GENERAL APPLICATION

Location Address: 2135 LINCOLN STREET

Explanation of Request: SUBMITTAL SITE PLAN APPROVAL - 16 UNIT APARTMENT BUILDING FINAL TAC

SUBJECT: Site Plan review for a 16 unit residential development.

SITE PLAN

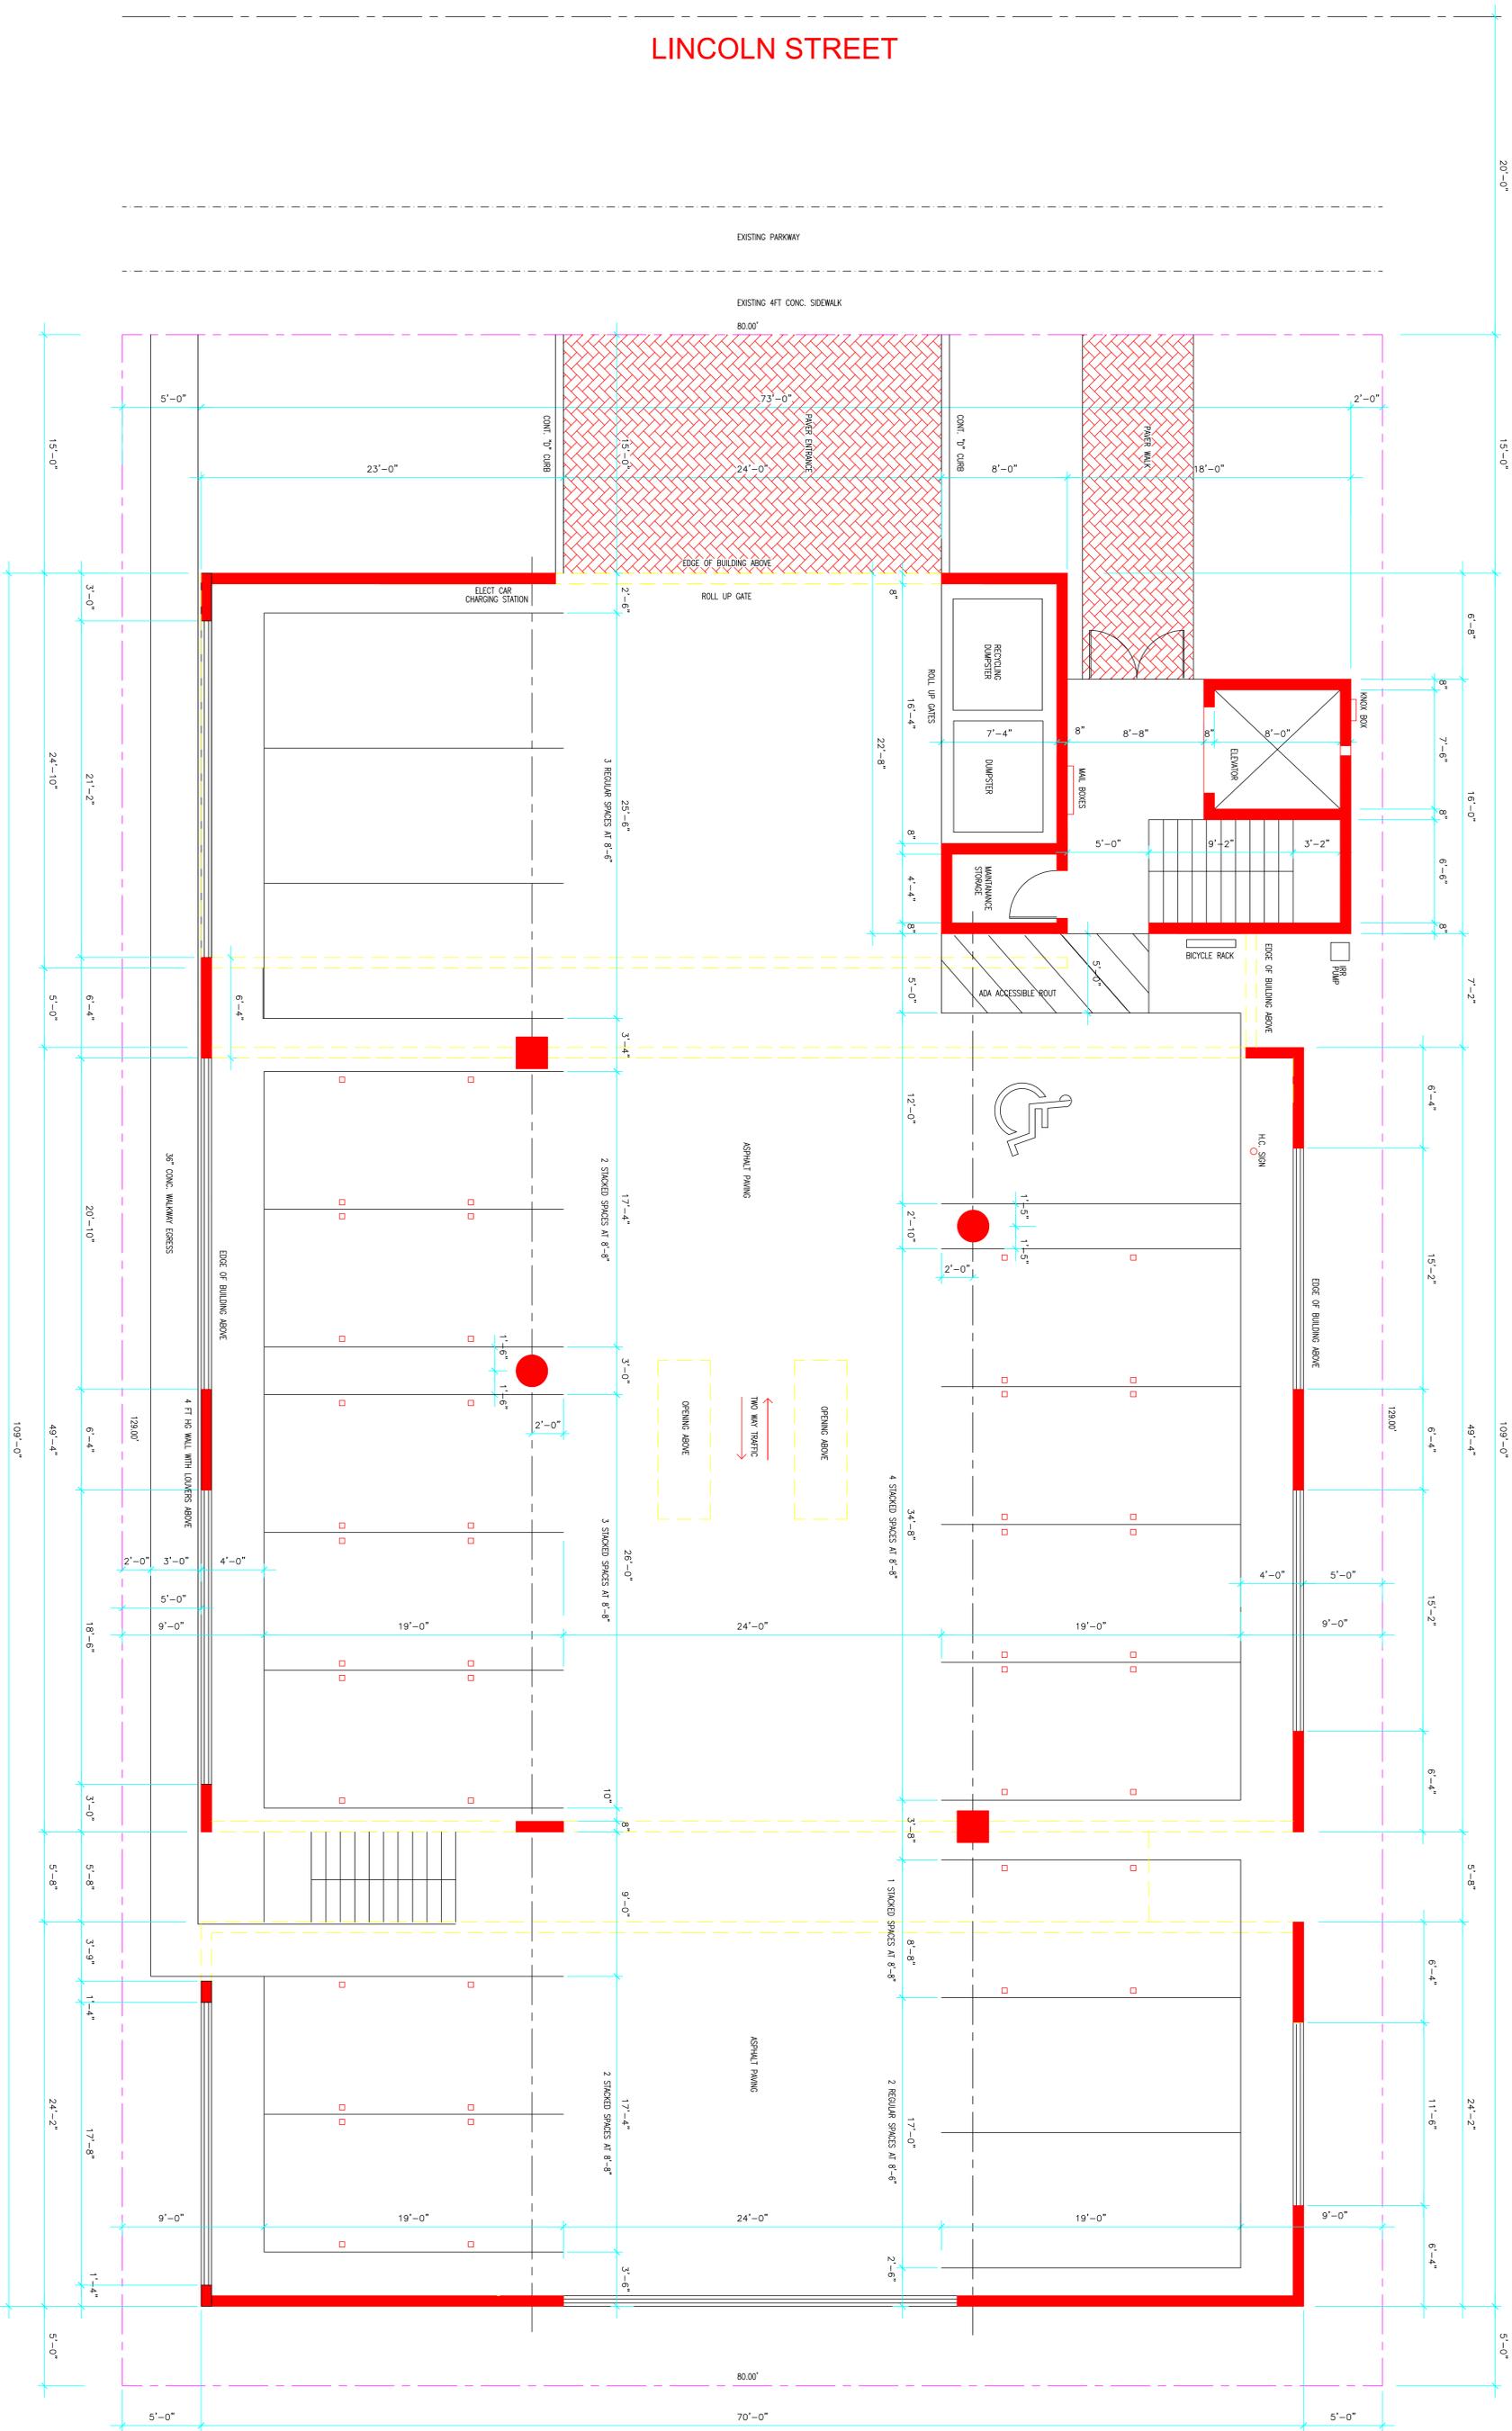
7. Revise the following on Site Plan:

- a. Indicate all required setback dimensions on the plan.
 - b. Indicate location for recycling.
 - c. Drawing shall be fully dimensioned, including but not limited to, architectural projections.

- d. Include note on Site Plan indicating that all changes to the design will require planning review and may be subject to Board approval.
8. Revise the following on Site Data Table:

- h. Curbing and side walk lines extend beyond the property line. Revise accordingly.
9. Complete and submit to Broward County School Board an impact fee application prior to submitting for Board consideration. Website:
<http://www.broward.k12.fl.us/propertygmt/new/growthmanagement/docs/PublicSchoolImpactApplication.pdf>
